TECHNICAL BULLETIN

Ticking Noise From Left side Footwell – EVAP Canister Purge Valve – Repair Procedure

MODEL 2003-05 MY
XK Range
VIN A30645-A40920

Remove and destroy Bulletin 303-62, dated 11/03.
Replace with this Bulletin.
Revised to include installation of new insulation pad.

ILLUSTRATION 1

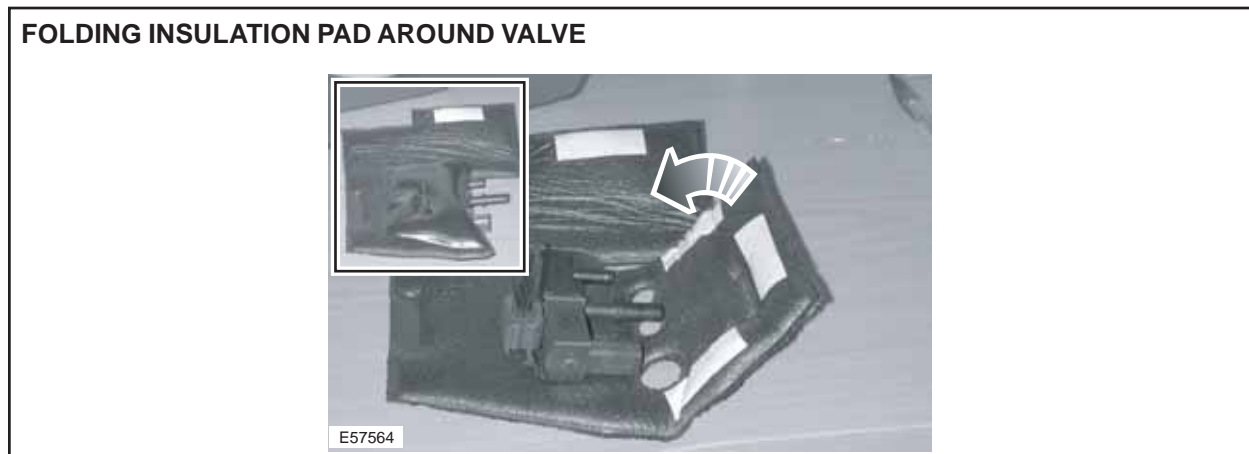
3. Insert the EVAP canister purge valve into the new insulation pad, fold the insulation pad around the EVAP canister purge valve and secure (Illustration 1).

ILLUSTRATION 2

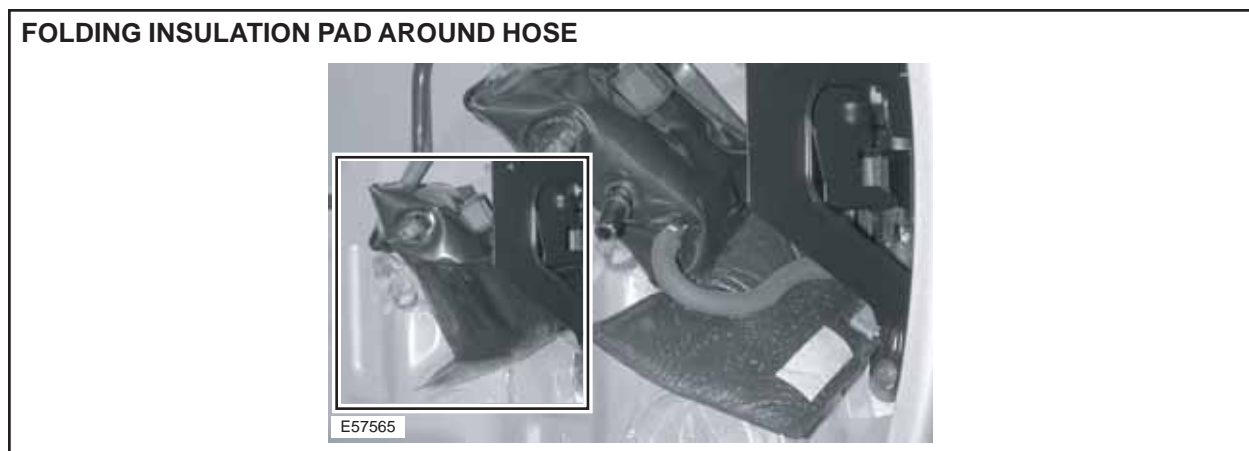
Note: When installing the EVAP canister purge valve on the vehicle, connect the lower hose to the valve and fold insulation pad around the lower hose and secure (Illustration 2).
